# Access Report

DCI Poplars Data Centre  
2 Wolseley Place, Jerrabomberra.

Prepared for: HDR/DCI Data Centres  
Our Ref: 25000086 | Issue date: 12-Feb-25

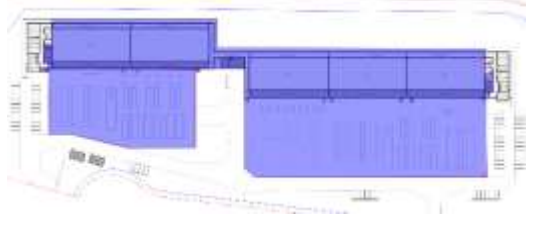
The assessment of the design documentation has revealed that the following areas or items are departures from the NCC BCA 2022 and are required to be assessed against the relevant Performance Requirements of the NCC BCA 2022. These are as following:

DTS Clause	Description of Non-Compliance	Performance Requirement
D4	<p>There is currently no compliant accessible path from the allotment boundary to the Data Centre building’s Principal Pedestrian Entrance (PPE), as required by AS 1428.1 under the BCA/NCC.</p> <p>To address this deviation, a Performance-Based Solution must be implemented. The proposed solution involves using the accessible car parking bay adjacent to the Data Centre building’s PPE as an alternative access point, rather than from the allotment boundary.</p> <p>Further details will be provided at a later stage.</p>	D1P1

The above Performance Based Solution will be subject to consultation and approval by relevant stakeholders as part of the CC process via the performance-based design process (PBDB).

Figure 5. - Site Plan, Source: HDR, 2024

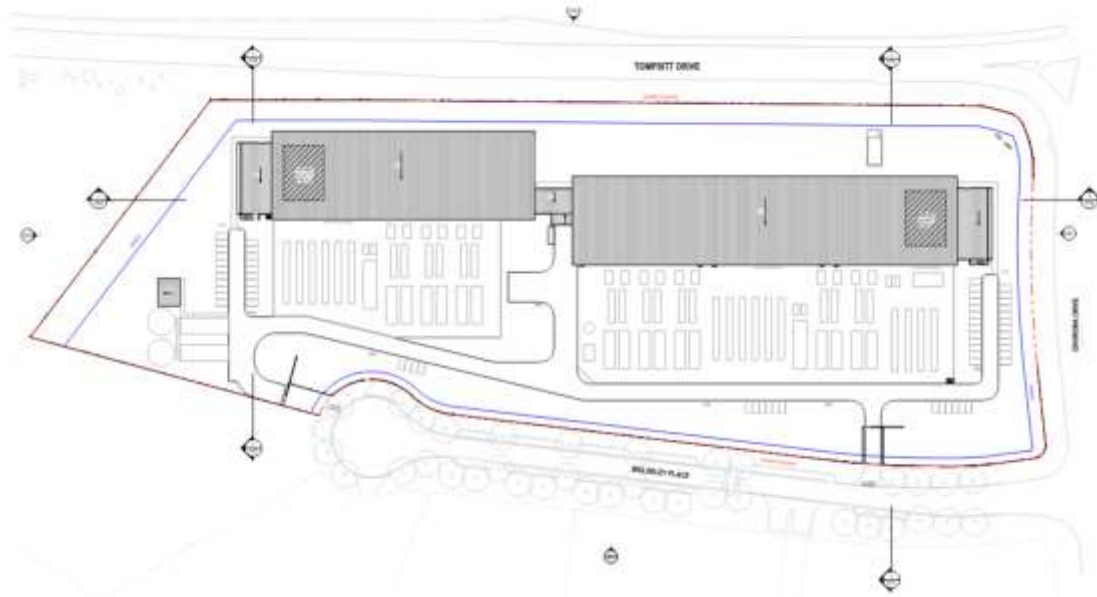
Compliance Comments
<ul style="list-style-type: none"> <li>○ There is a lack of access from the allotment boundary. This is a departure to be address under a Performance Solution. Refer to item 1.1 for further information.</li> </ul> <p><b><i>The proposal can readily achieve compliance with the BCA Accessibility provisions and DDA.</i></b></p>
